# Corning Sub-basin GSA Committee Meeting Materials

May 11, 2022 | 9:30 a.m.

# Public Comments Received During the Public Comment Period

Re: Comments on the Corning Groundwater Sustainability Plan

### **GW Monitoring Network**

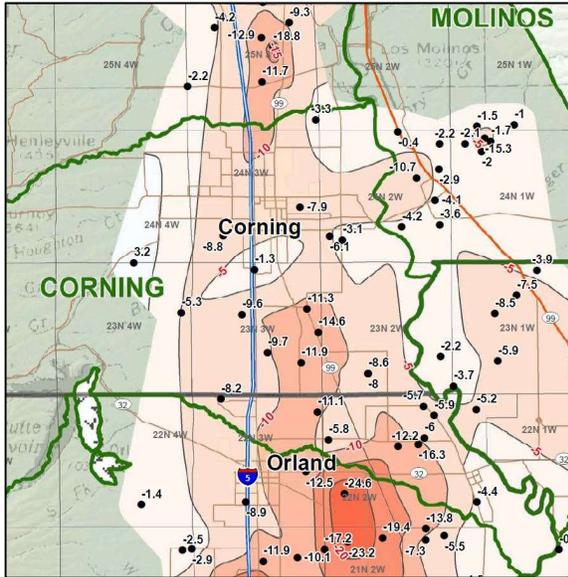
The GSP identified localized spatial data gaps near Thomes Creek extending to northeast of the City of Corning. The plan states that “over a period of the first few years of GSP implementation, the GSAs will identify existing wells for groundwater monitoring in the data gap areas for chronic lowering of groundwater levels and depletion of interconnected surface water sustainability indicators.”

The importance of addressing data gaps to monitor groundwater levels and the potential depletion of ISW cannot be overstated. Given that the subbasin is in overdraft and many domestic wells are being impacted, there should be some level of urgency to address this problem. Minimum Thresholds also need to be established for these areas.

23 CCR §354.34(b) also requires that the plan include an explanation of how a network will be developed and implemented to monitor ISW. It's clear that for parts of the subbasin, existing wells are not a proxy for monitoring the depletion of ISW. This effort should be elevated to Projects and Management Actions with a clearly defined scope and implementation schedule.

Figure 1. Corning Subbasin Fall Change Maps (Fall groundwater levels for selected years as compared to Fall 2020 groundwater levels for wells ranging between 200 to 600 feet deep)

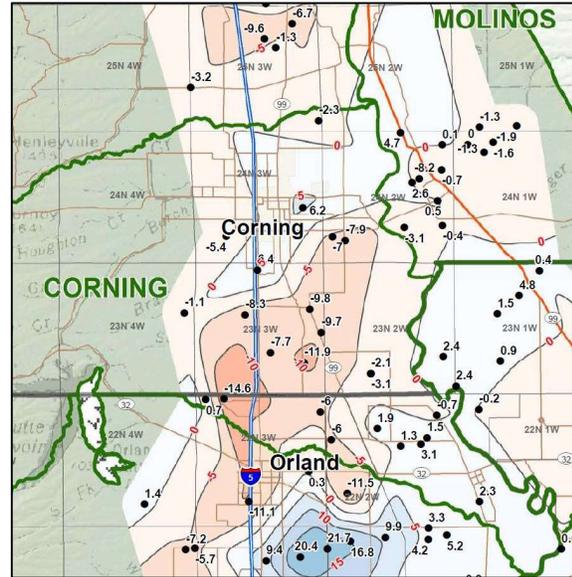
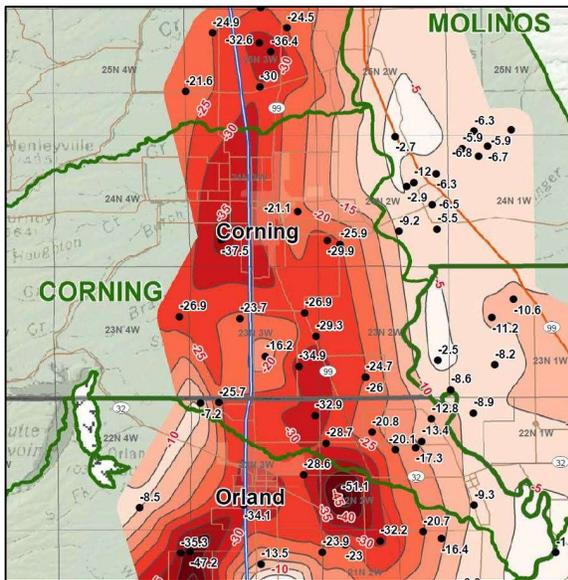
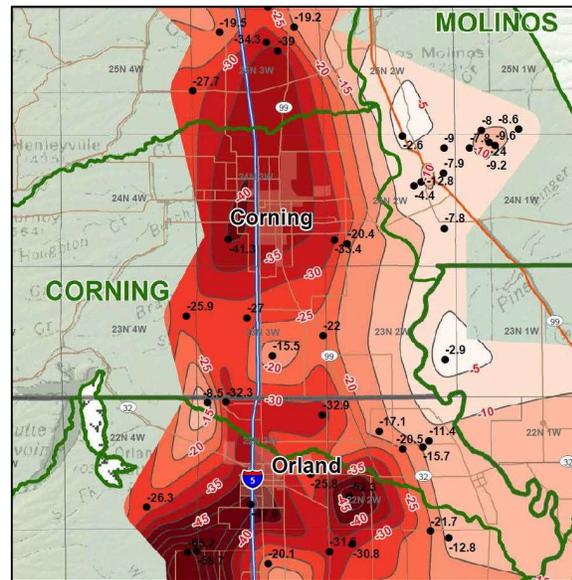
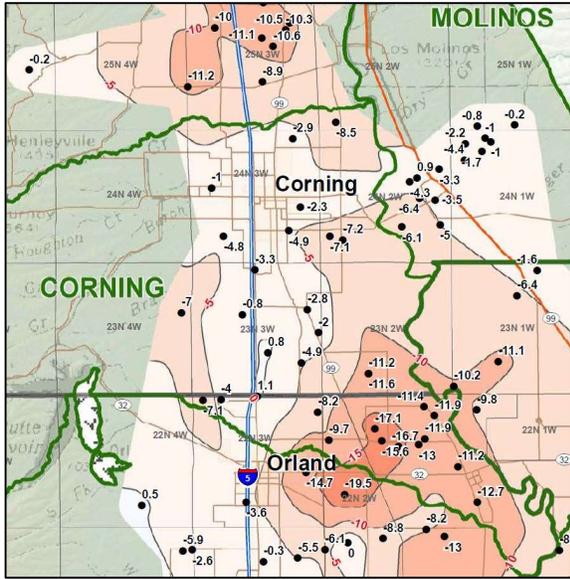
An important issue that needs to be addressed in the Corning Groundwater Sustainability Plan (GSP) is the groundwater overdraft condition of the subbasin. Groundwater level trends are illustrated in Figures 1 and 2. The general trend for spring groundwater levels shows that groundwater has declined between 8 and 34 feet for different parts of the subbasin since 2004. For the one-year period of 2019 through 2020, groundwater levels declined between 1 and 17 feet. This data was developed by California Department of Water Resources (DWR) based on spring and fall measurements taken from wells with depths ranging from 200 to 600 feet.

An important issue that needs to be addressed in the Corning Groundwater Sustainability Plan (GSP) is the groundwater overdraft condition of the subbasin. Groundwater level trends are illustrated in Figures 1 and 2. The general trend for spring groundwater levels shows that groundwater has declined between 8 and 34 feet for different parts of the subbasin since 2004. For the one-year period of 2019 through 2020, groundwater levels declined between 1 and 17 feet. This data was developed by California Department of Water Resources (DWR) based on spring and fall measurements taken from wells with depths ranging from 200 to 600 feet.

Modified Table 4D-35. Corning Subbasin Projected 2070 Land Surface Budget, Annual Average by Water Year Type

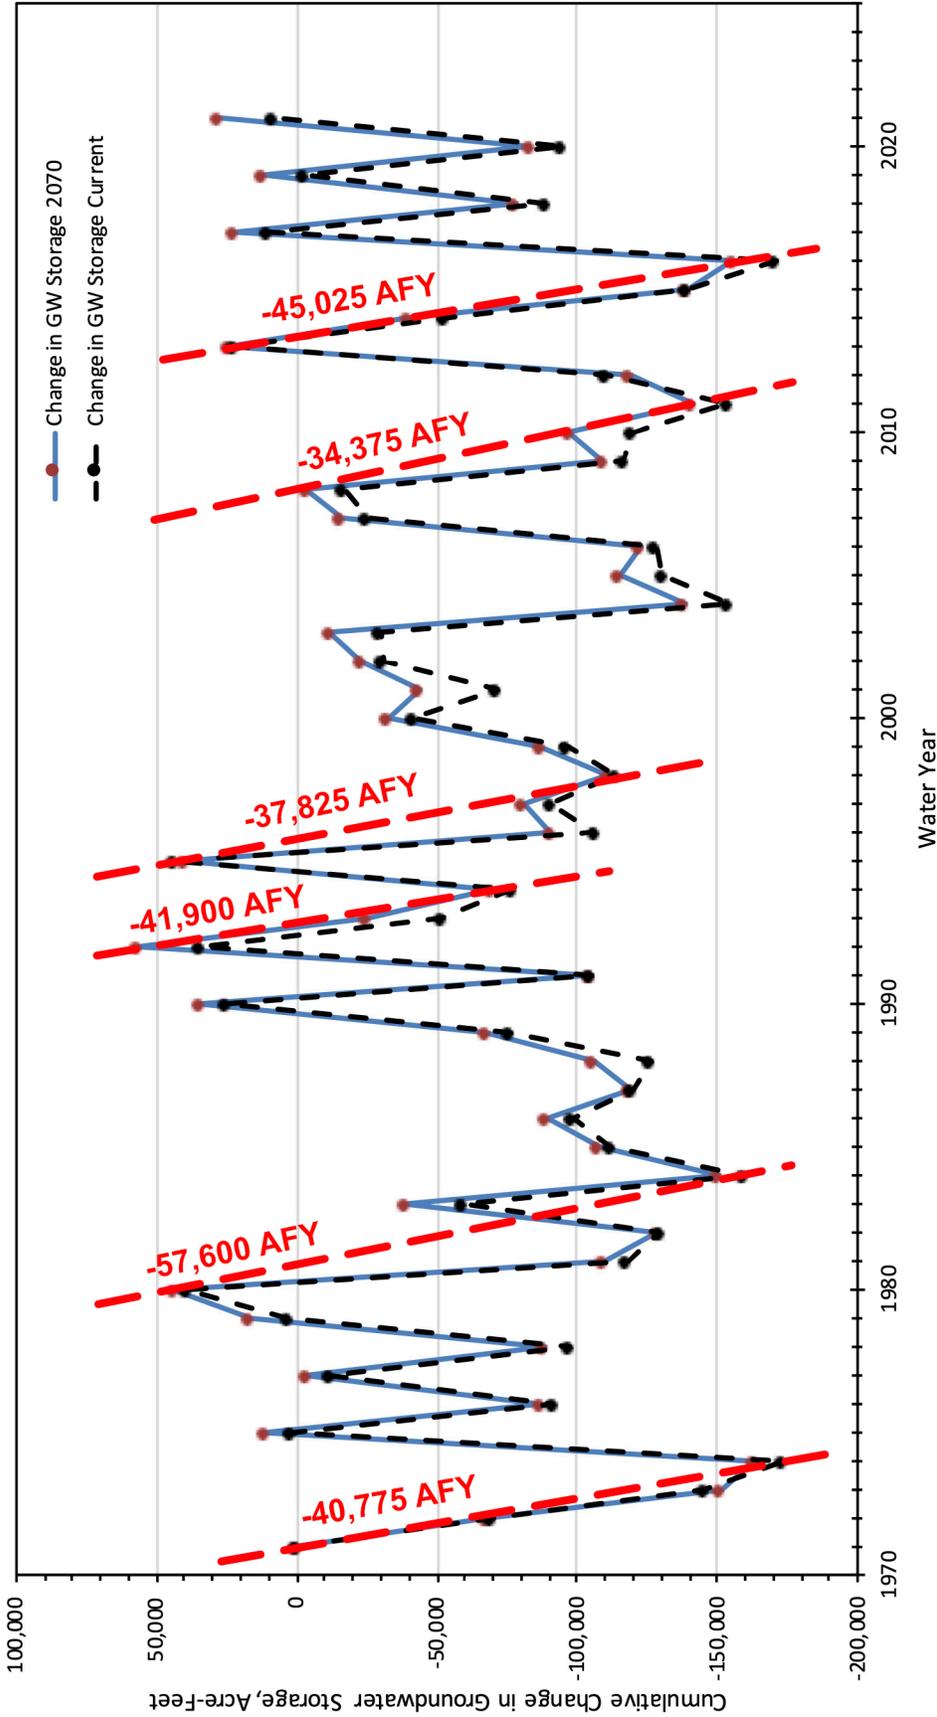
8. AquAlliance Exhibit 5 gives the values for the Land Surface Budget for the Historical baseline, part A, and the projected 2070 scenario, part B. The differences between the baseline and the 2070 scenario are given in part C. Overall there is an increase in the total inflow and outflow with the 2070 scenario, Exhibit 5C (rows 26 and 31, columns C through J). However, the direction of change is not the same for each water budget component.

The 2070 scenario inflow for precipitation and applied groundwater both increase over the Historical baseline, but the applied surface water decreases. For the 2070 scenario the total outflow increases with the increases in evapotranspiration and overland flow. These increases in outflow appear to cause the decrease in deep percolation and return flow to streams, Exhibit 5C (rows 27 and 30, columns C through J). The total change in soil and unsaturated zone storage from Historical baseline to the 2070 scenario is negative for the annual average and the BN/AN water year, positive for the CD/D drought water years, and zero for the wet years, Exhibit 5C (row 32, columns C through J). It is unclear if the loss in return flow to streams in the Land Surface Budget, Exhibit 5 (row 30), is a part of the net stream gains component in the Groundwater and Surface Water budgets, Exhibits 2, 3 and 4.
